Certain 2010 Model Year 4WD Tacoma Vehicles
Front Propeller Shaft Safety Recall
*****URGENT*****

Subject: Safety Recall – A0D
Certain 2010 Model Year Tacoma 4WD Vehicles
Front Propeller Shaft Inspection

Subject: Safety Recall – A0D
Certain 2010 Model Year Tacoma 4WD Vehicles
Front Propeller Shaft

TECHNICAL INSTRUCTIONS
FOR
SAFETY RECALL A0D
FRONT PROPELLER SHAFT INSPECTION
2010 MODEL YEAR TACOMA 4WD

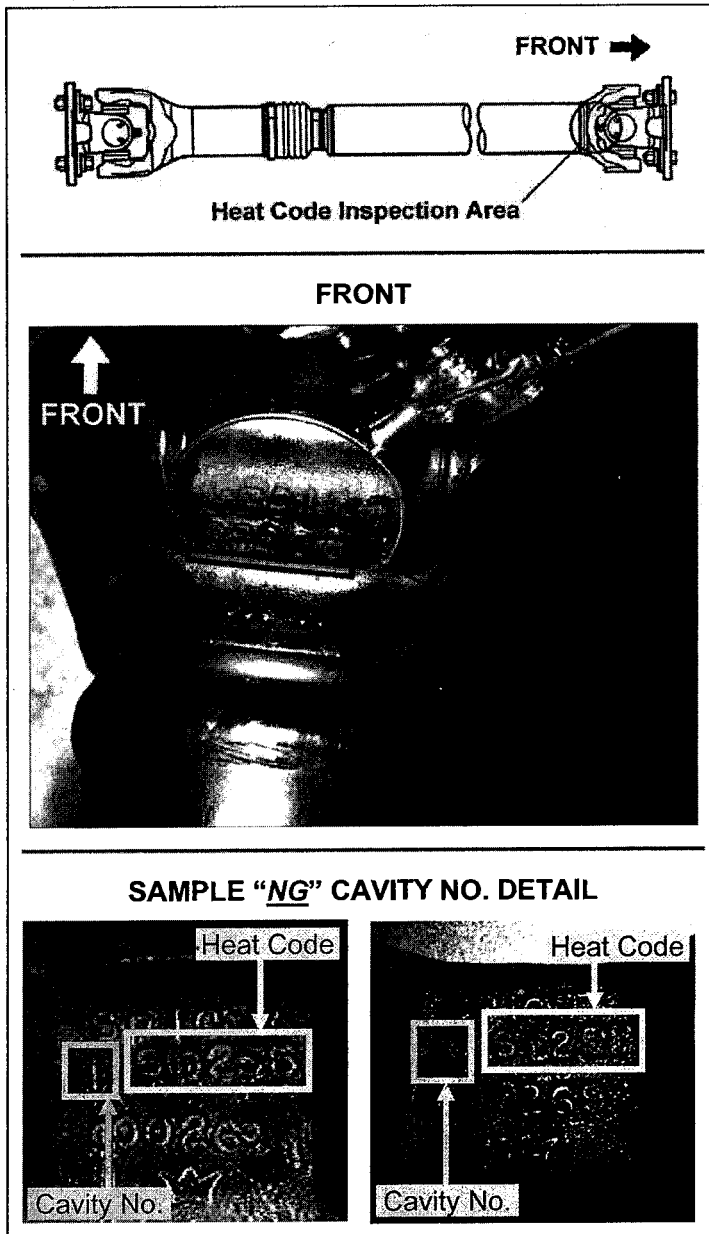
- a) Using a telescoping mirror and flashlight, locate the 5 digit Heat Code and 1 digit Cavity No. stamped on the front end of the front propeller shaft as shown in the illustrations.

The front propeller shaft may need to be rotated 180° to see the Heat Code and Cavity No.

- b) Does the front propeller shaft have a Heat Code of SD258 or SD231?

- c) Does the front propeller shaft have a Cavity No. of 1 or 3?

The front propeller shaft is NG / affected, Proceed to APPENDIX "A" for "FRONT PROPELLER SHAFT REPLACEMENT".

- a) Replace the "**Front Propeller Shaft**" and install a **NEW** one as outlined in the repair manual (TIS keyword: "Front Propeller Shaft Assembly".)
- b) Campaign completed
